PUR-1401
ADDENDUM NO. 5
INVITATION TO BID

WASHINGTON COUNTY PUBLIC SAFETY TRAINING CENTER

DATE: Thursday, September 10, 2020

CONCRETE DETAILS

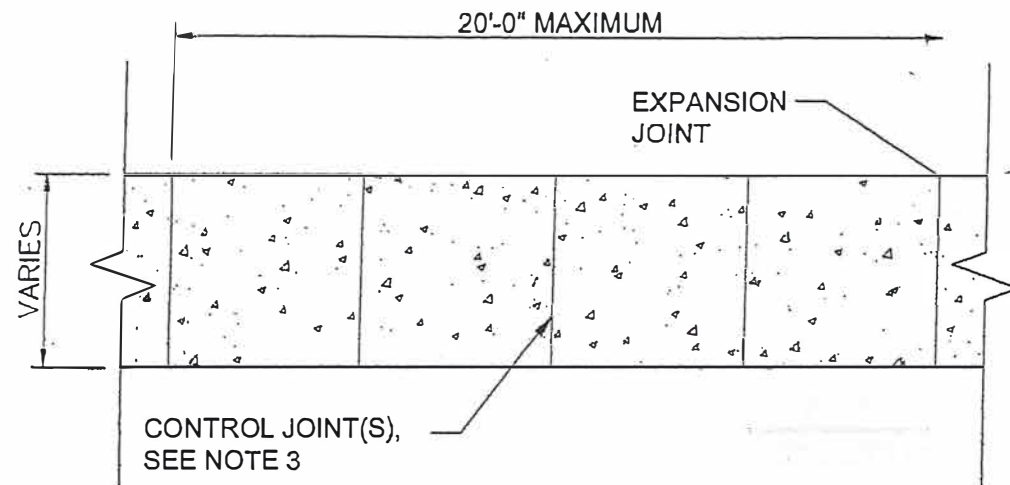
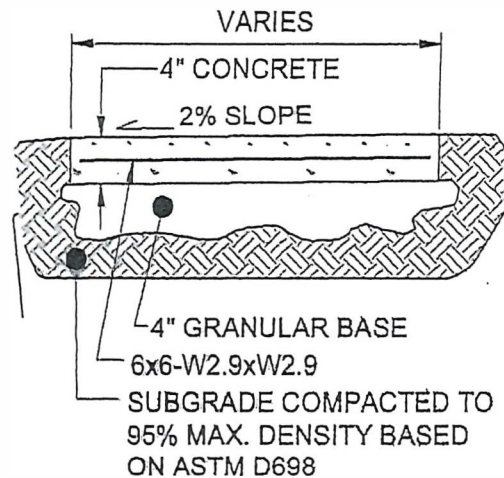
ITEM NO. 7: Inquiry: Please provide a sidewalk concrete detail showing expansion joint spacing, reinforcing requirements, at concrete type.

Response: See concrete sidewalk detail, Attachment "A". Scoring of concrete at main entrance to be as directed in field by the County using the minimum requirements provided.

1 FIRST FLOOR PLAN - UNIT A - POWER
SCALE: 1/8" = 1'-0"

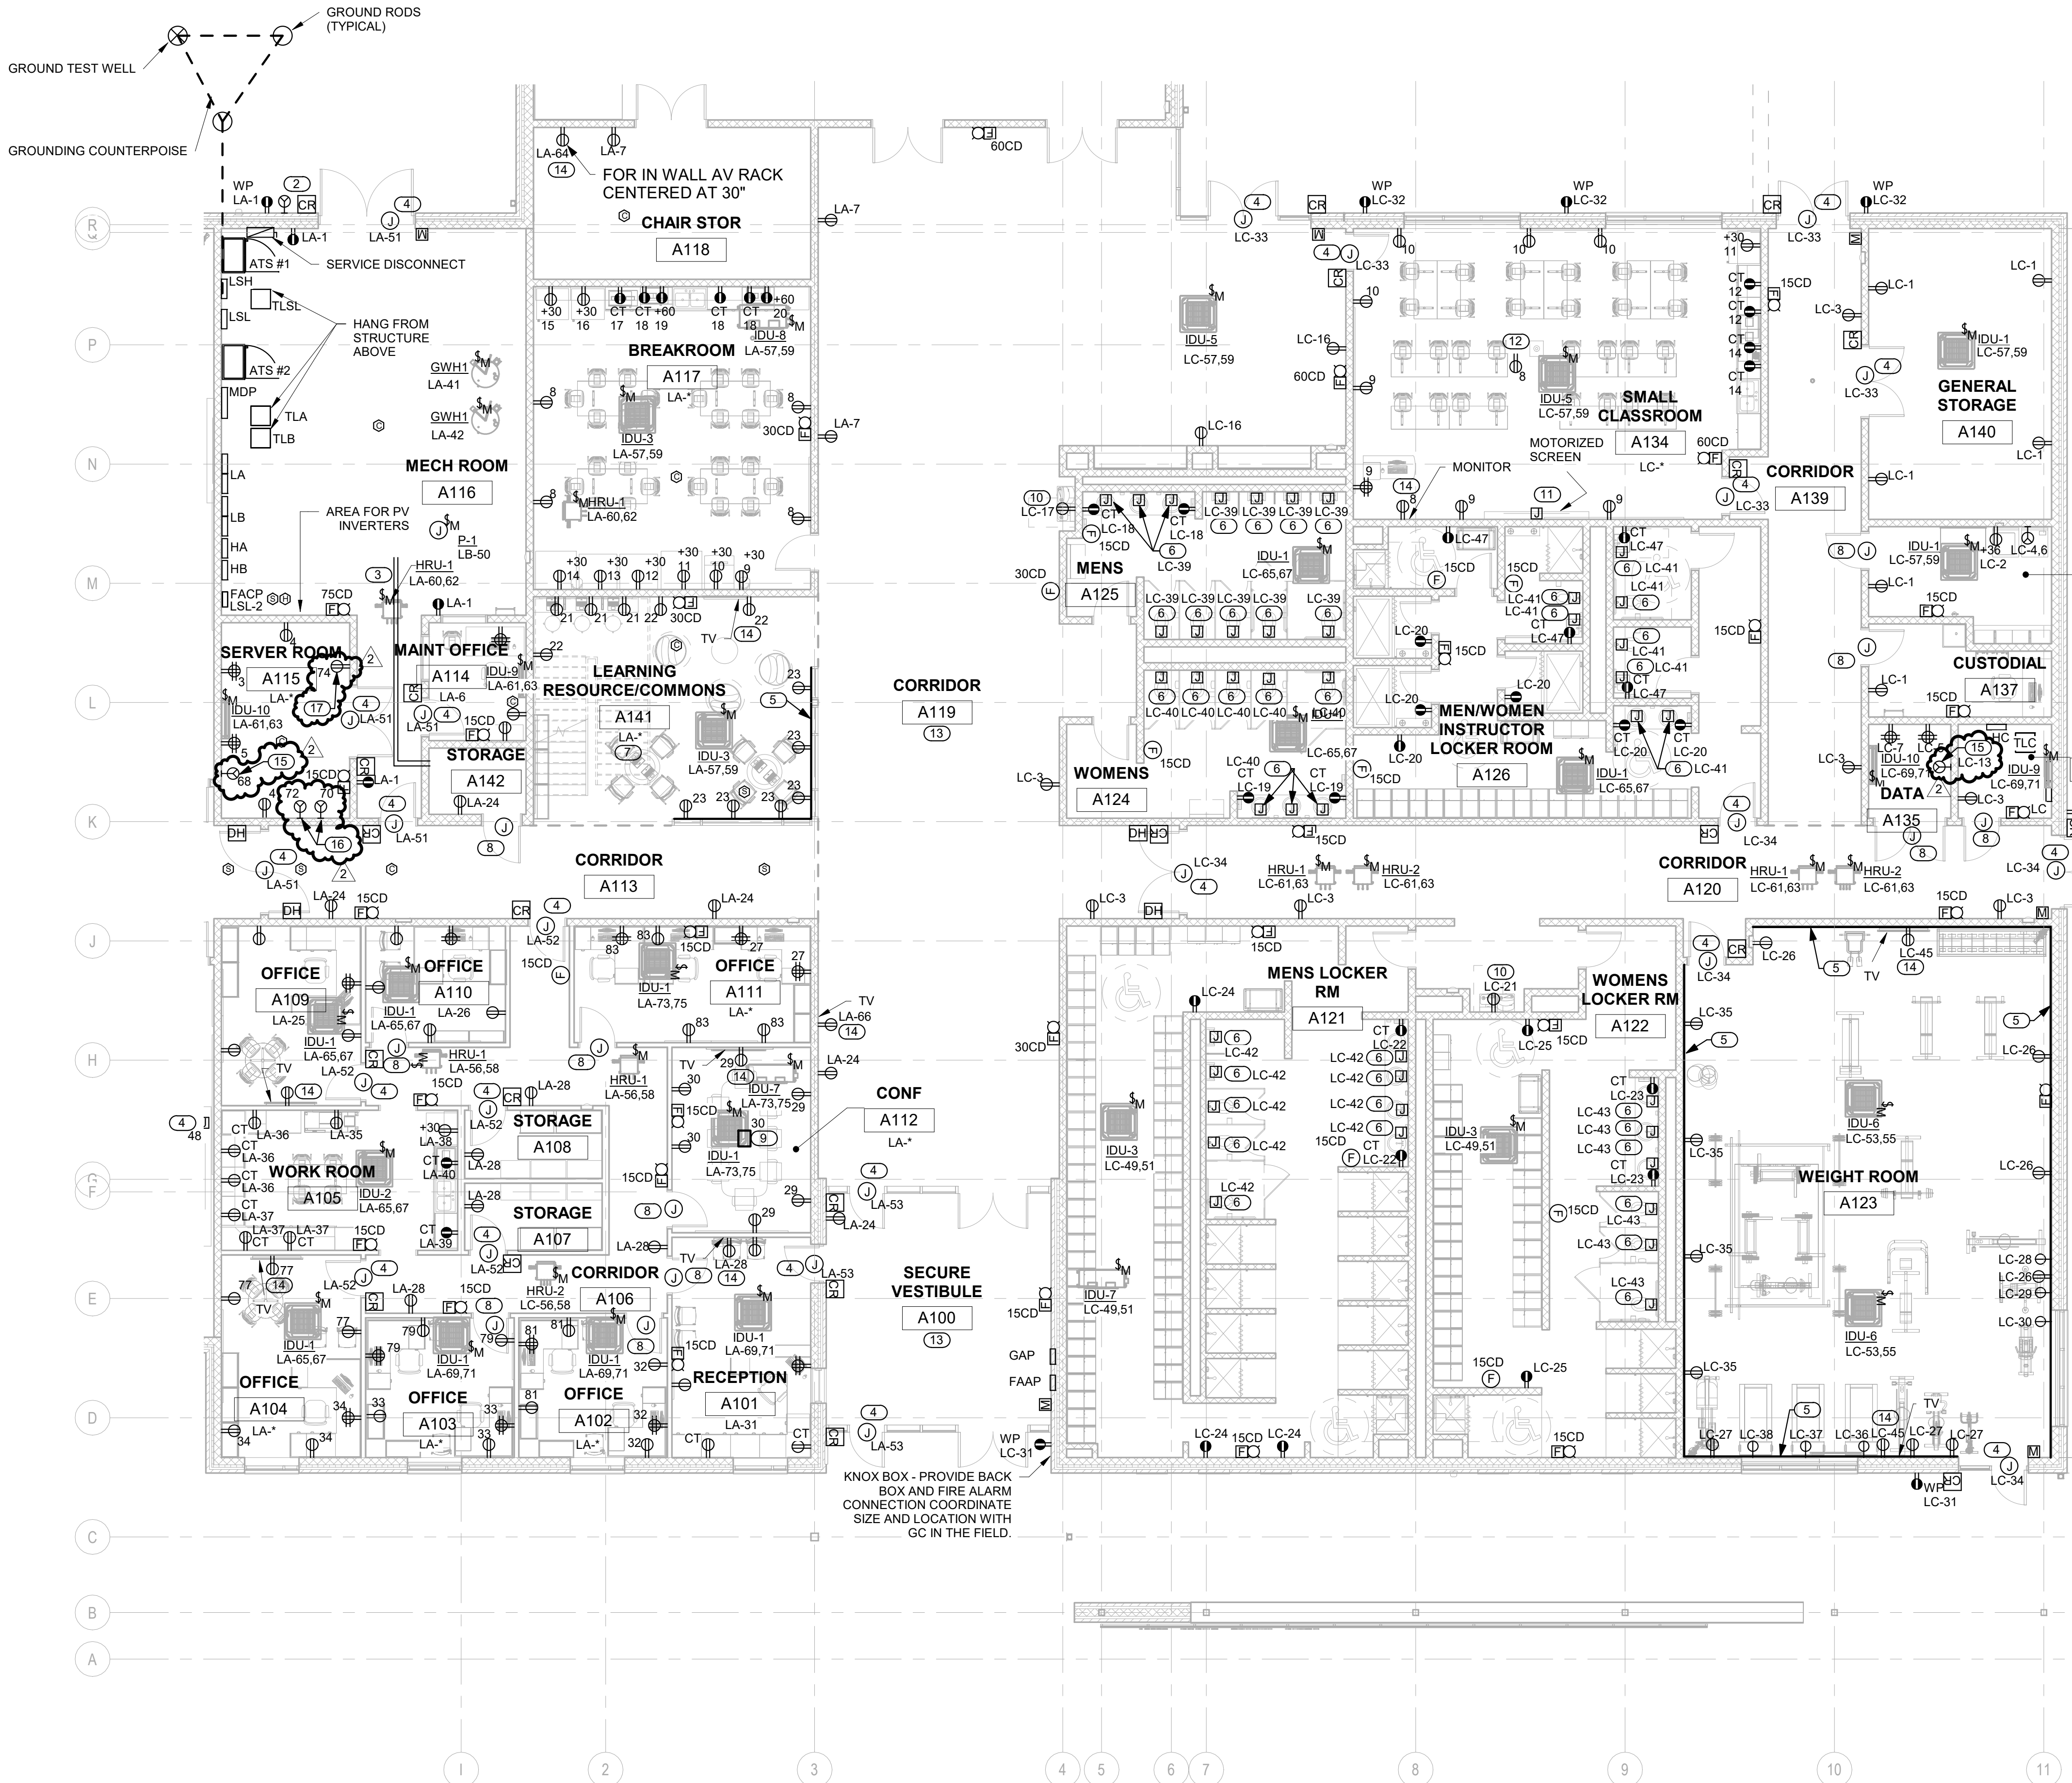
ITEM NO. 40: Drawing E1.0 – First Floor Plan – Unit A – Power, **CHANGE** the following:

1. NOTES BY SYMBOL, ADD notes 15, 16 and 17 per attached revised drawing.
2. FIRST FLOOR PLAN – UNIT A – POWER, ADD symbols/notes to the floor plan per the attached revised drawing, (Attachment C).

1 FIRST FLOOR PLAN - UNIT B - POWER
SCALE: 1/8" = 1'-0"

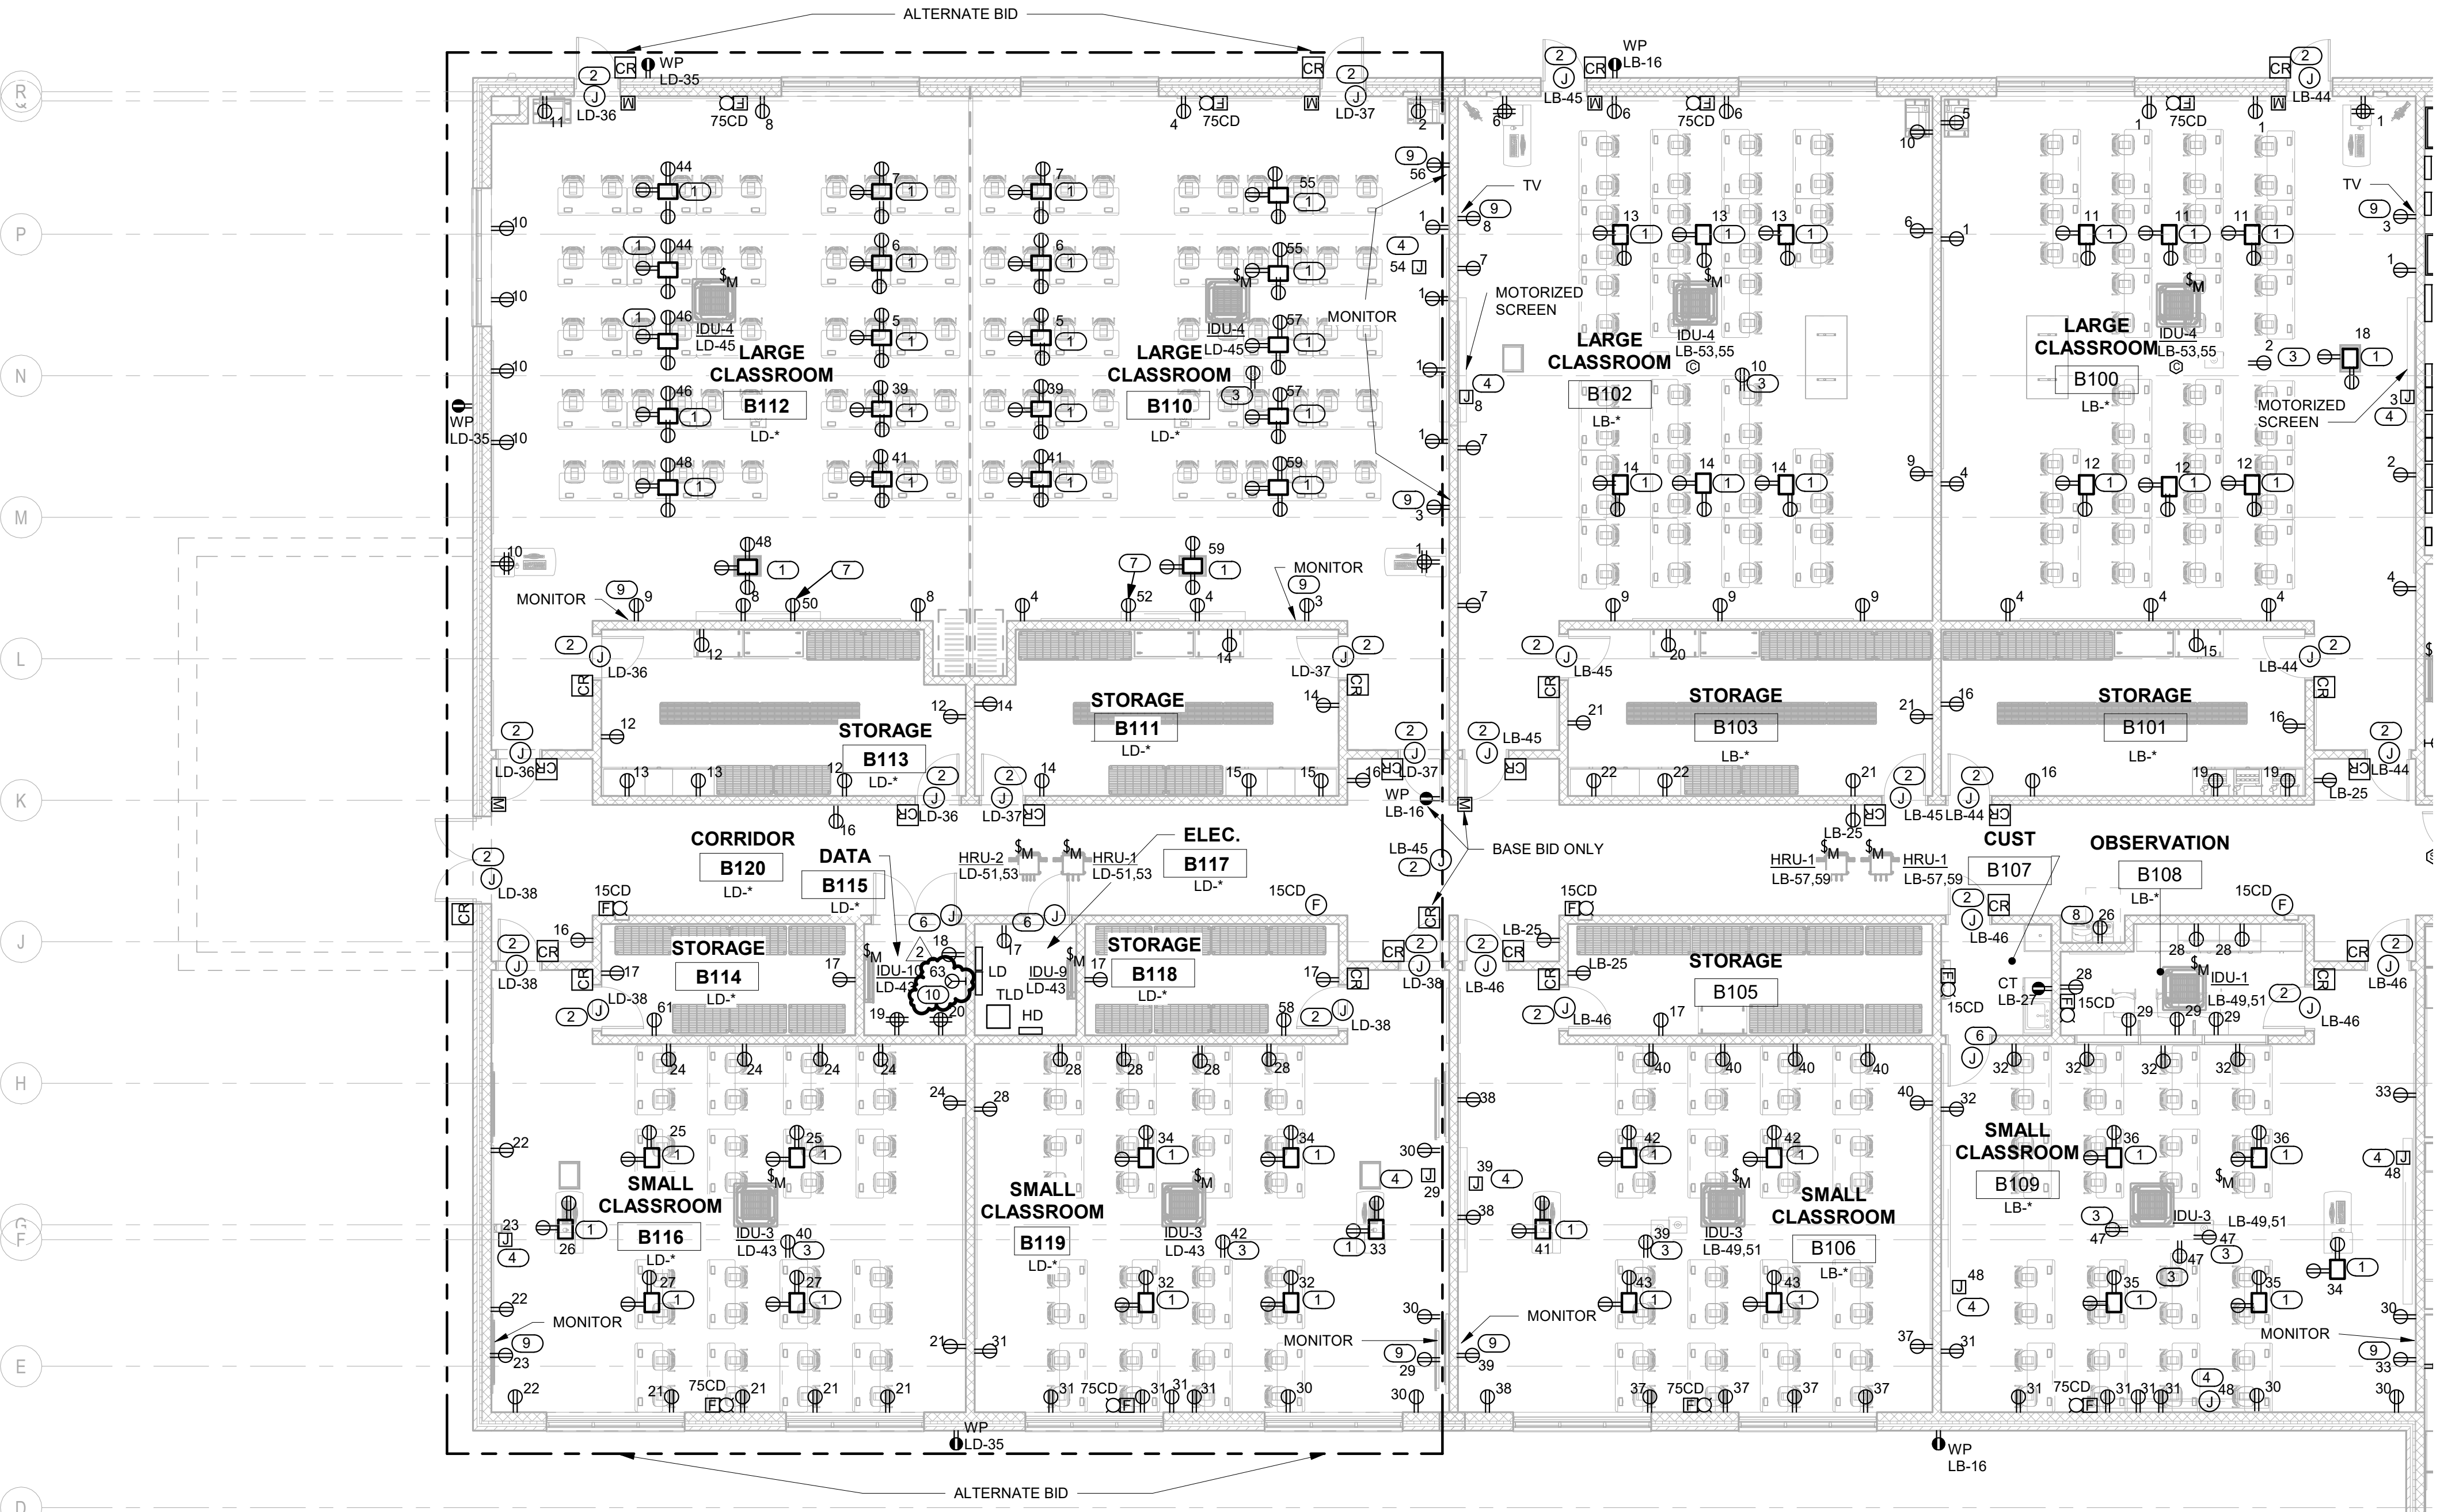
ITEM NO. 41: Drawing E1.1 – First Floor Plan – Unit B – Power, **CHANGE** the following:

1. NOTES BY SYMBOL; **ADD** note 10 per attached revised drawing.
2. FIRST FLOOR PLAN – UNIT B – POWER; **ADD** symbols/notes to the floor plan per the attached revised drawing, (Attachment D).
